Written Submission to 10 December 2024 Ordinary Meeting of Council – Item UP24/57 Proposed Reclassification of Lots 2674 and 2335 (4-6) Almondbury Road, Ardross from Public Open Space to A Class Reserve – Notice of Motion).

Prospective Reclassification of Crown Reserve 33422 to Class A Reserve – Preliminary Assessment – November 2024

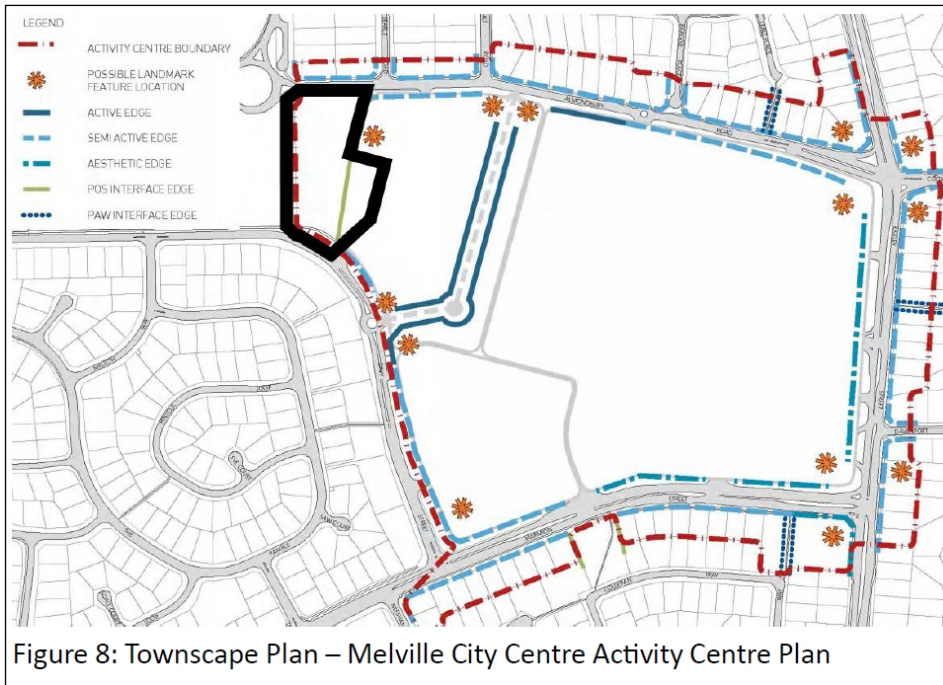
In Figure 7, the Class C portion is within the Activity Centre boundary.

Does Figure 7 suggest that the proposed land use within the Class C portion will not be passive under the Melville City Centre Activity Centre Plan?

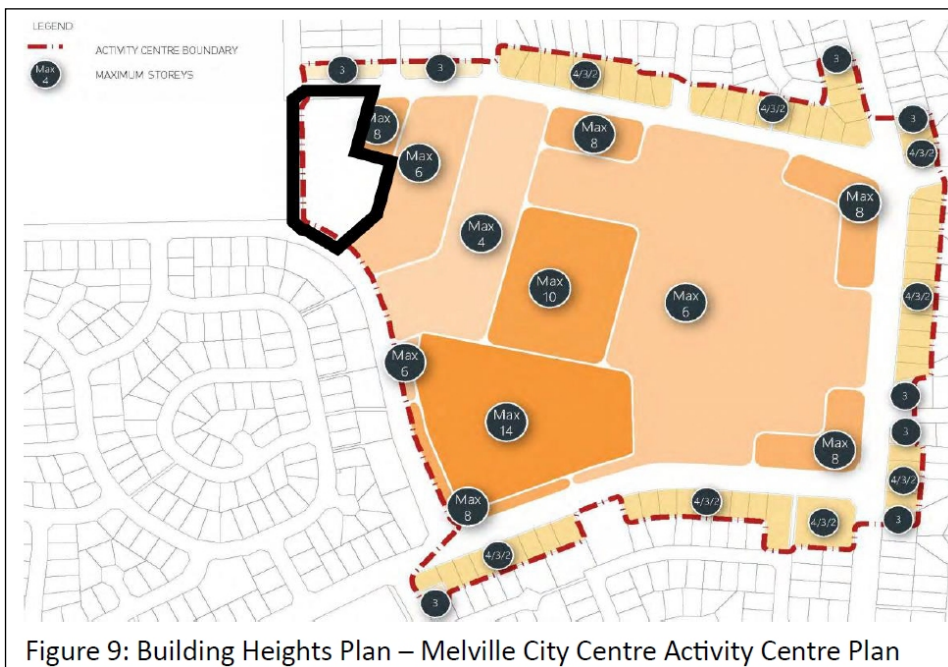
Figure 8 shows a Public Open Space interface edge in green within the Class C portion.

Does the interface edge in Figure 8 indicate that there will be two separate areas of different land use or activity levels within the Class C portion, and what land uses or activities are envisaged in each?
